CONCEPT PLAN III
STREET BAPTIST
ALEXANDRIA, VIRGINIA

Mr. Michael Swidrak, AICP
Urban Planner
City of Alexandria
Development Division
301 King Street
Room 2100
Alexandria, VA 22314

We are in receipt of your comments dated June 21, 2016. Many changes have been incorporated into this submission based on City Staff as well as Community input, including adding a third level of underground parking on site. As a result, the Applicant is submitting this Concept III submission so Staff has the most current plans being proposed. The following are our responses to your comments:

STANDARD PASSENGER CAR AT DUKE STREET AND ALFRED STREET INTERSECTION:

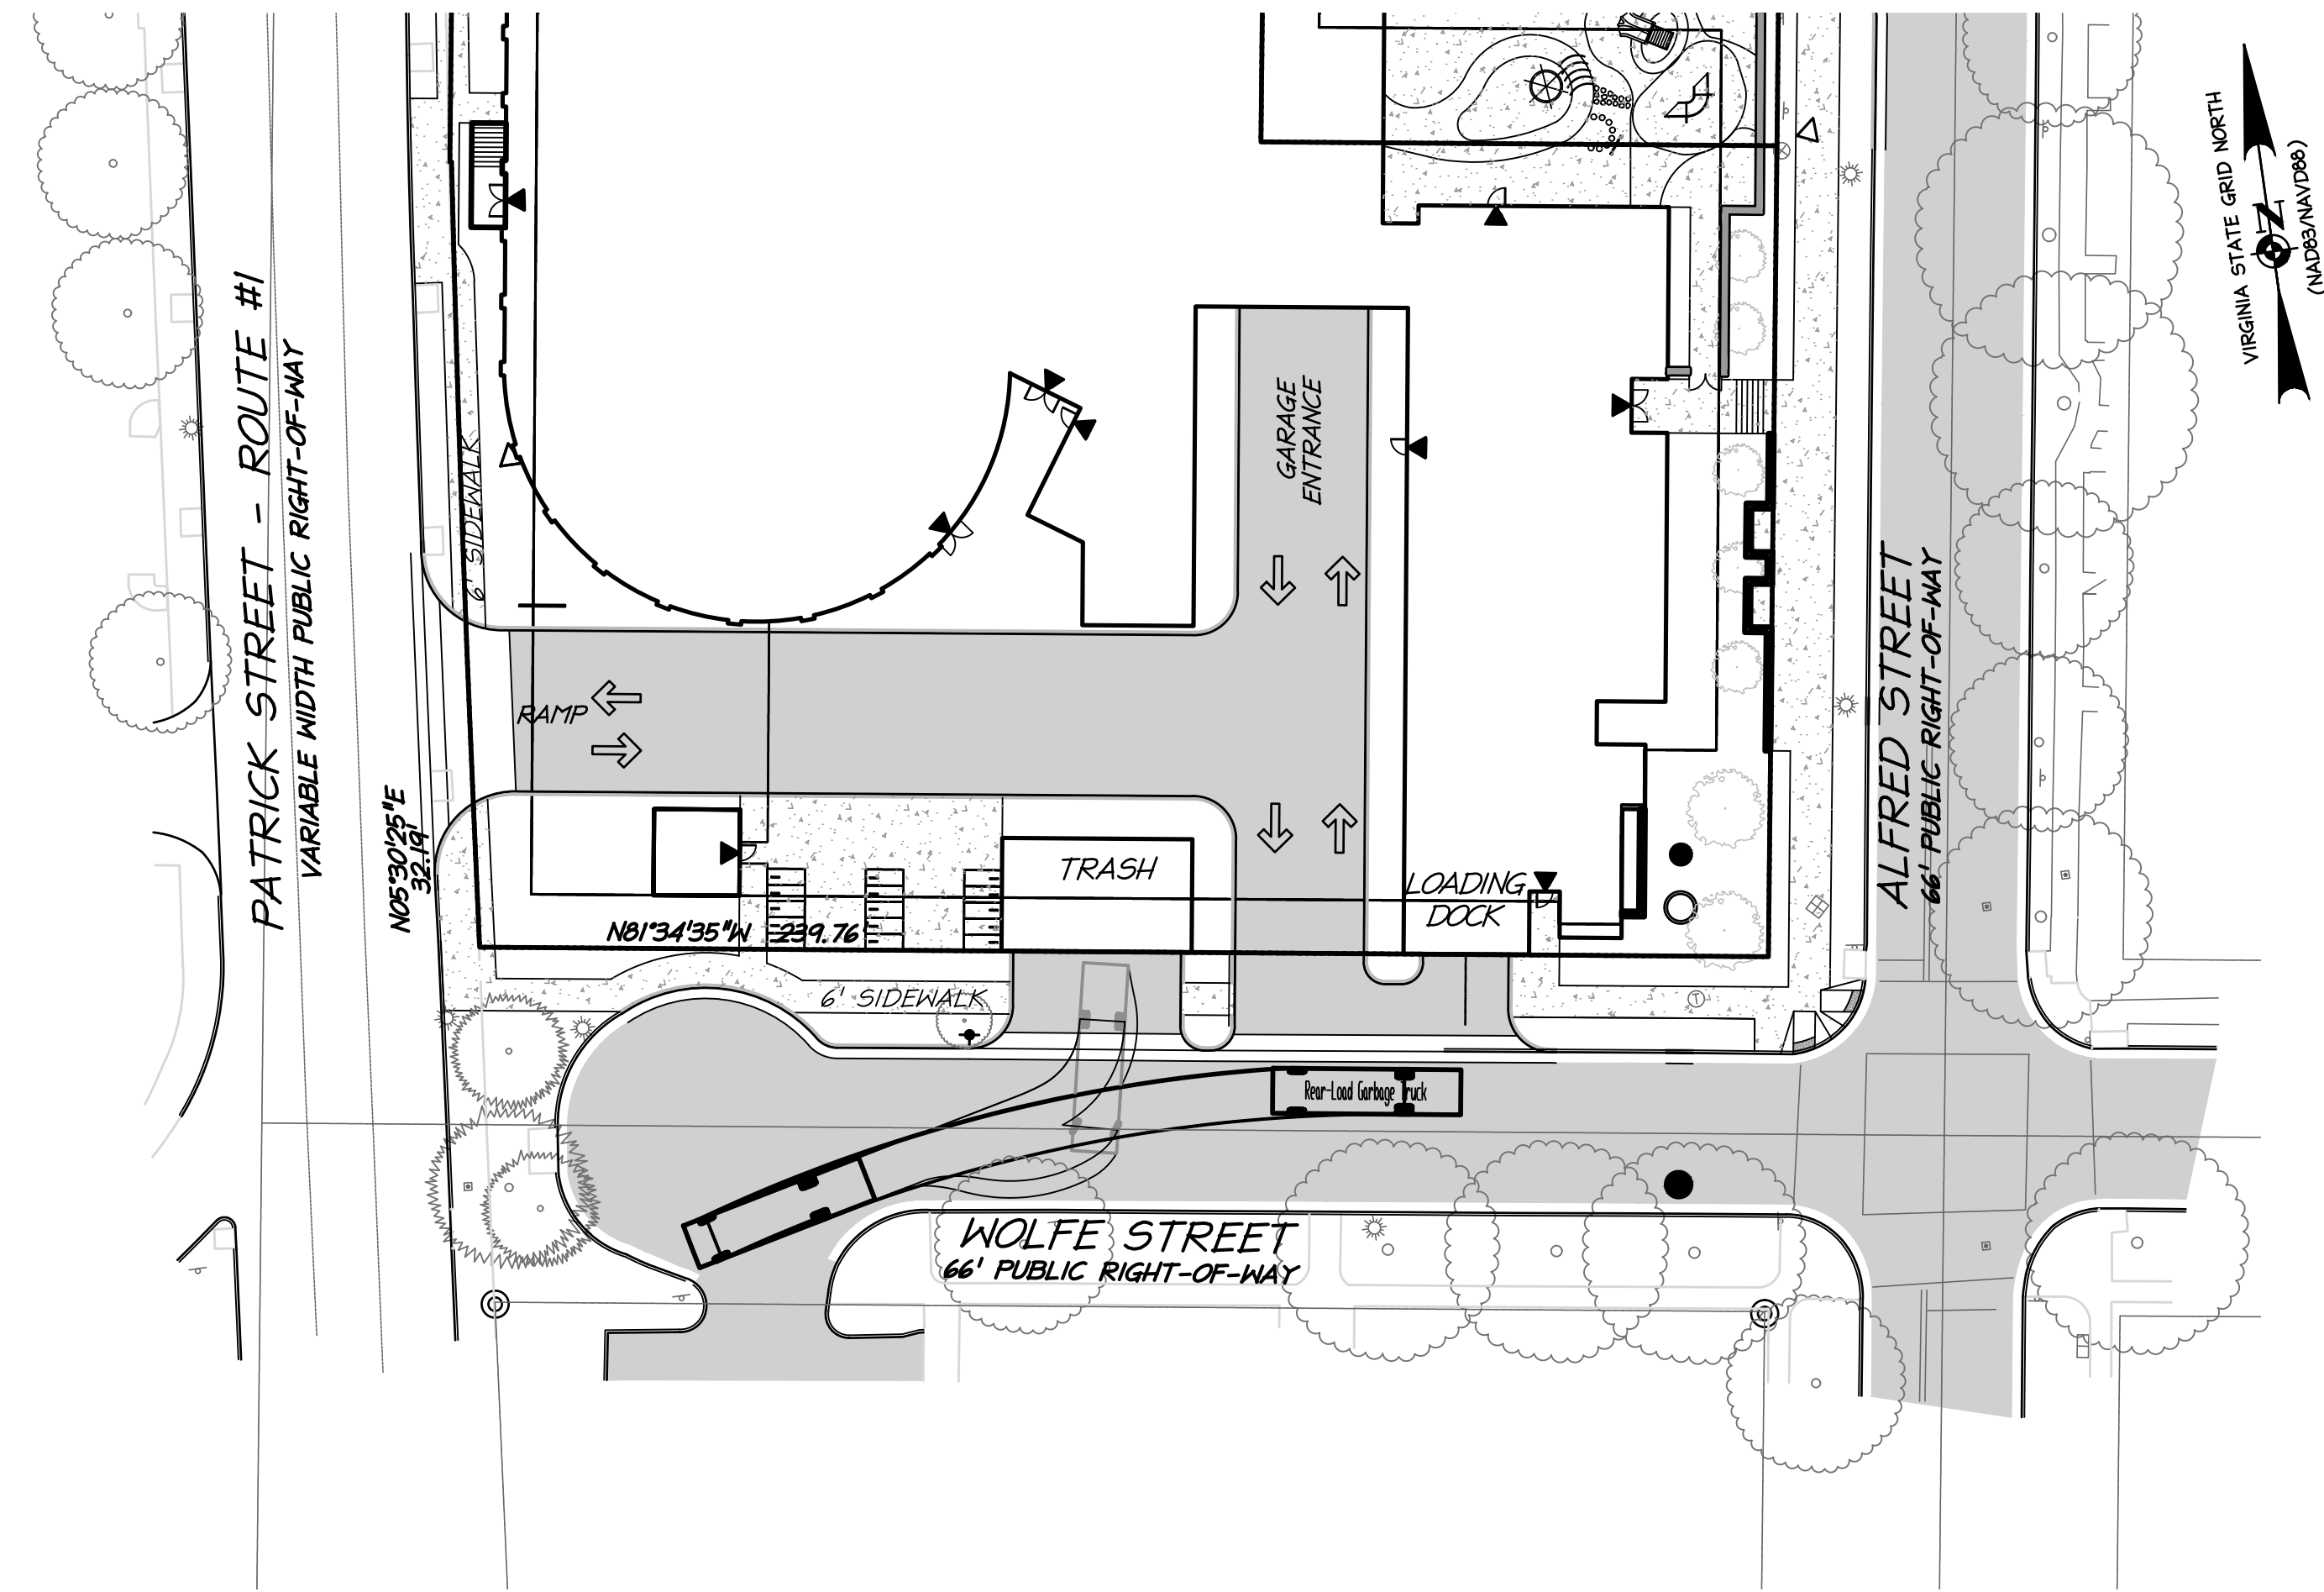
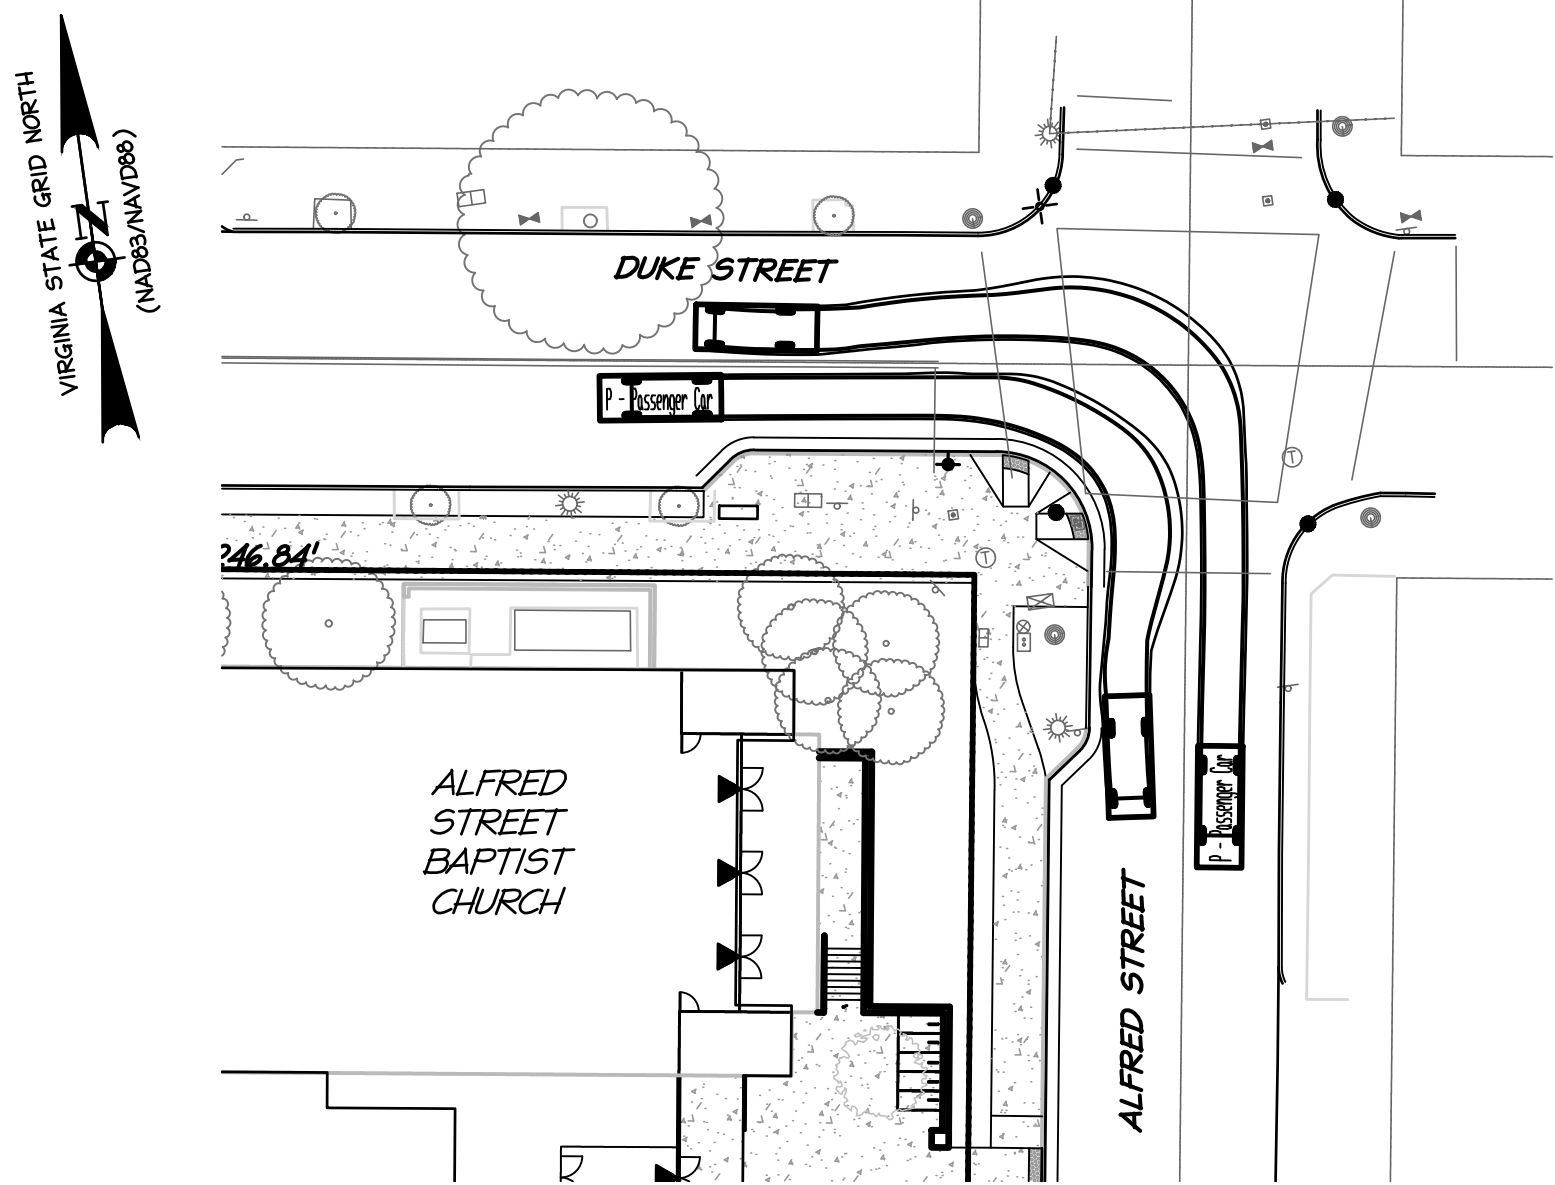
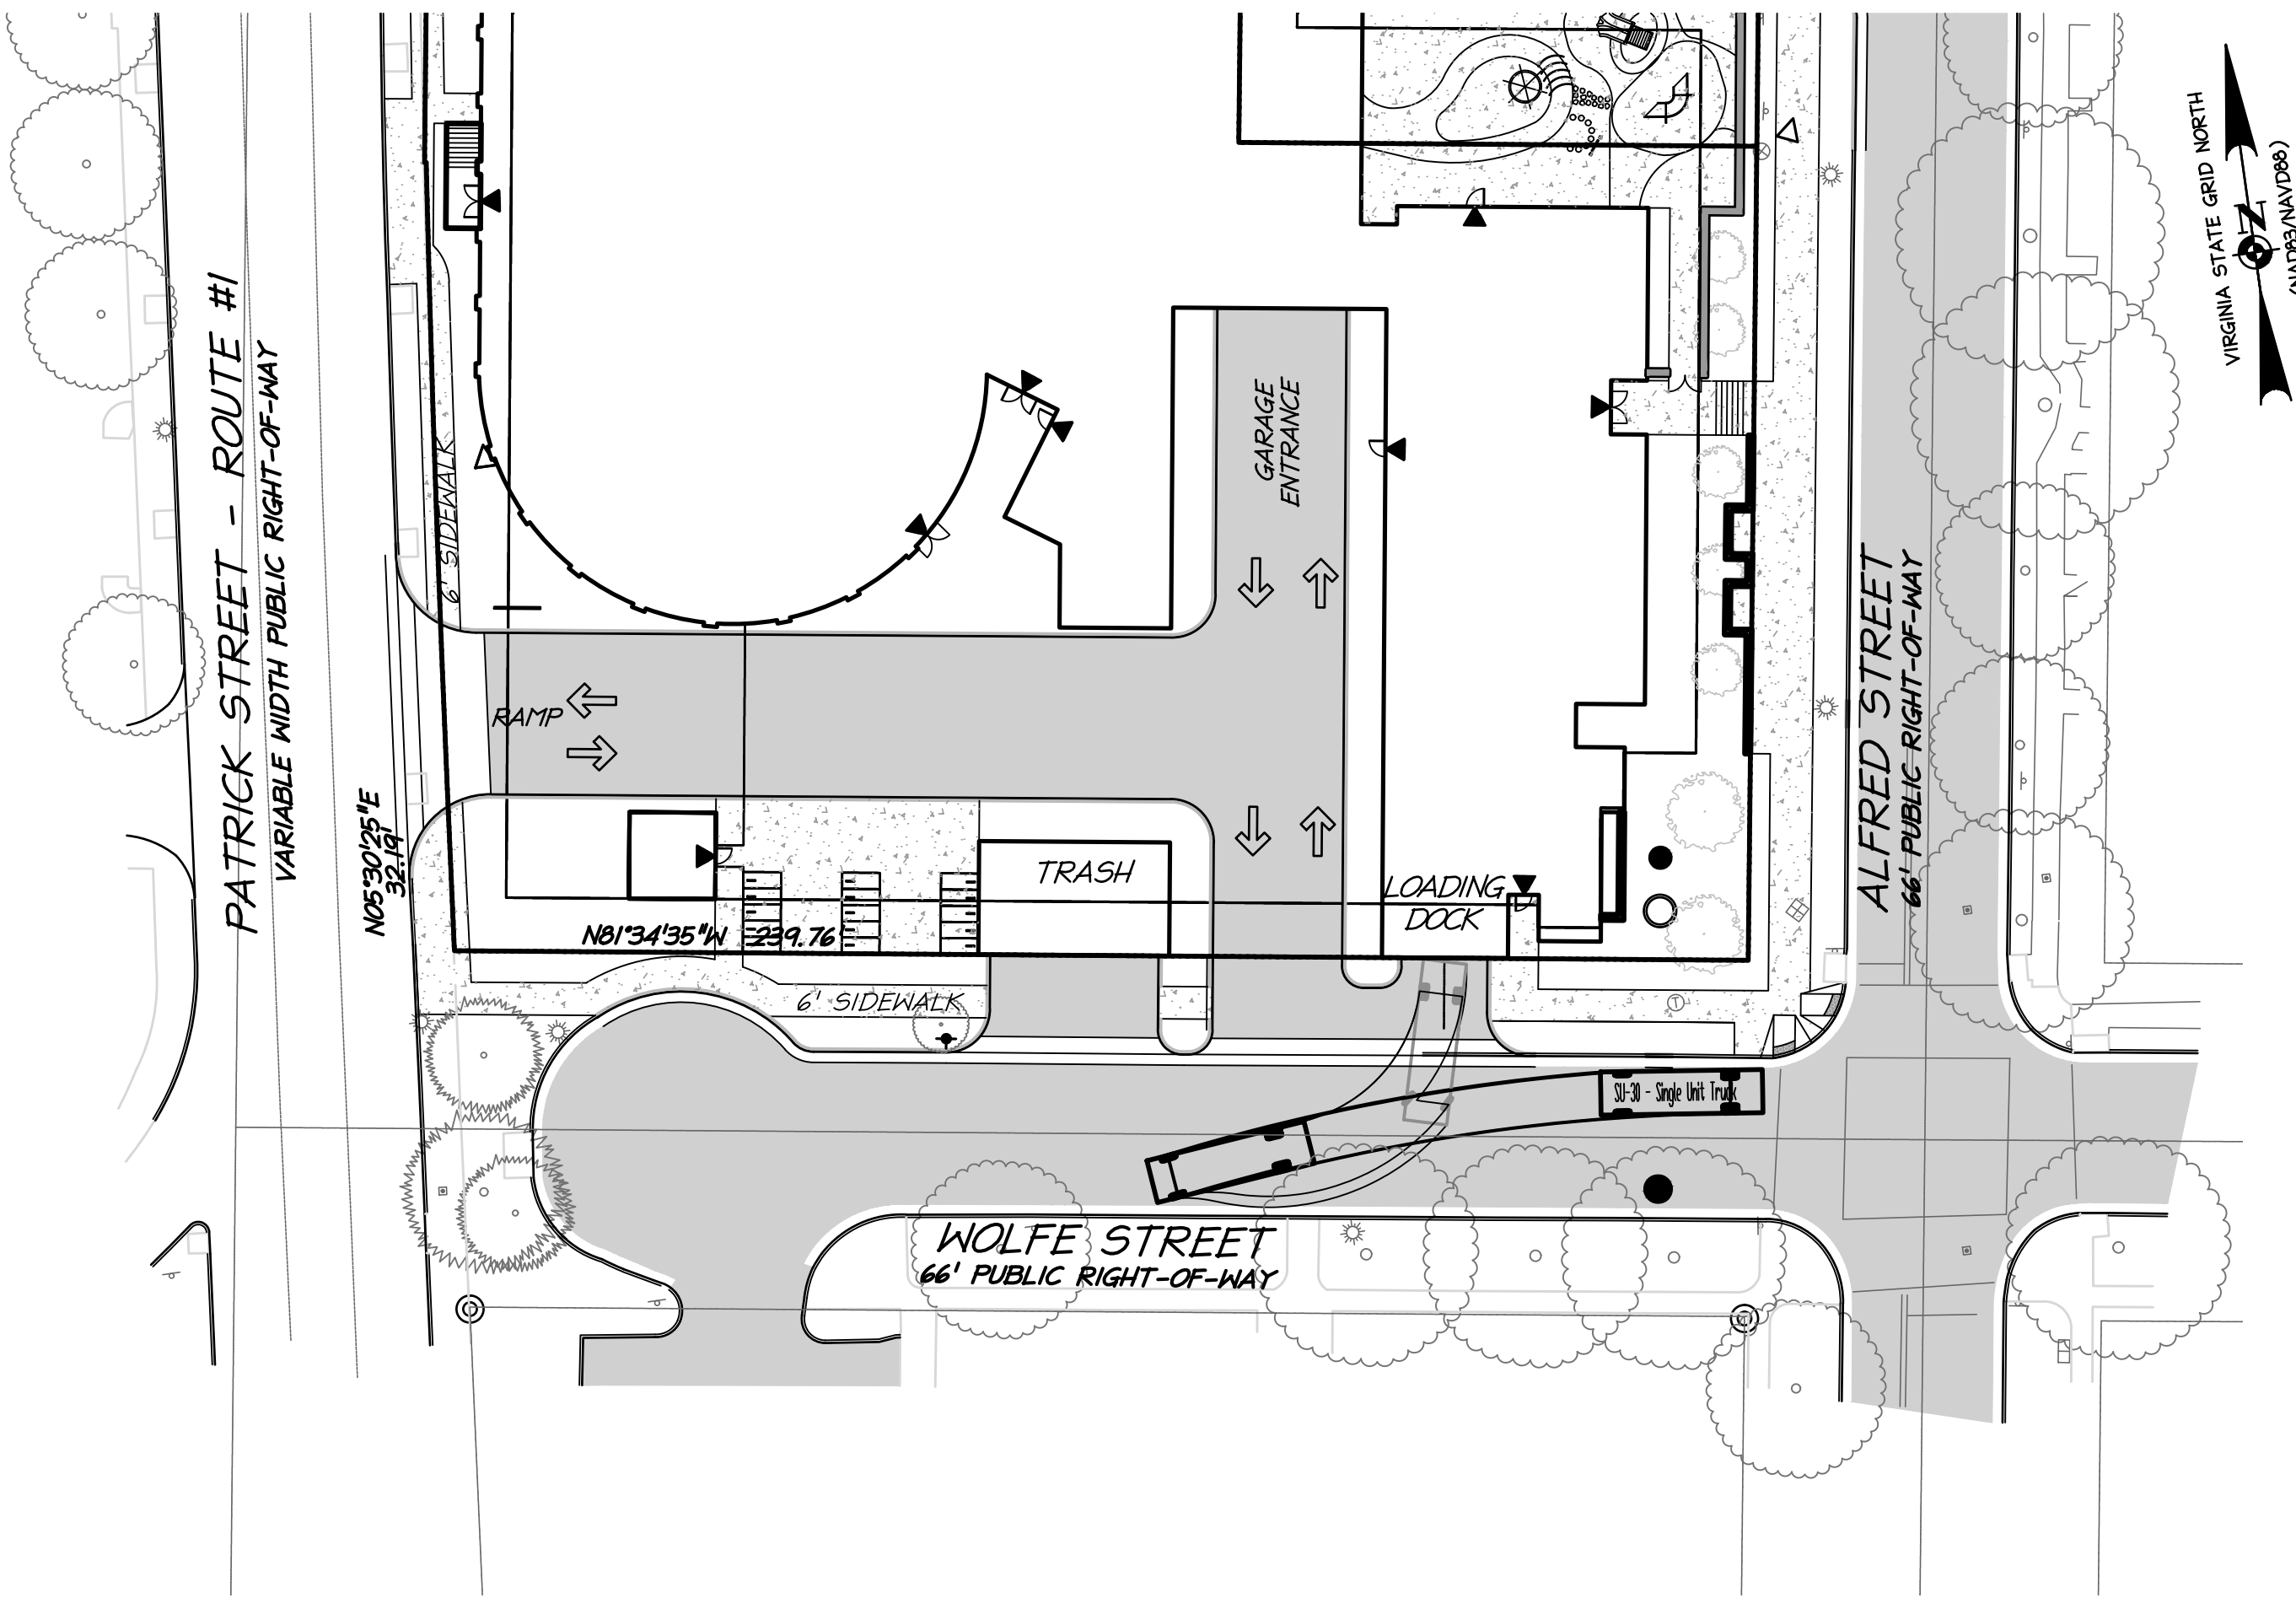
11. Provide turning movement at Duke St and Alfred St. (Transportation)

Response: Refer to sheet C600.
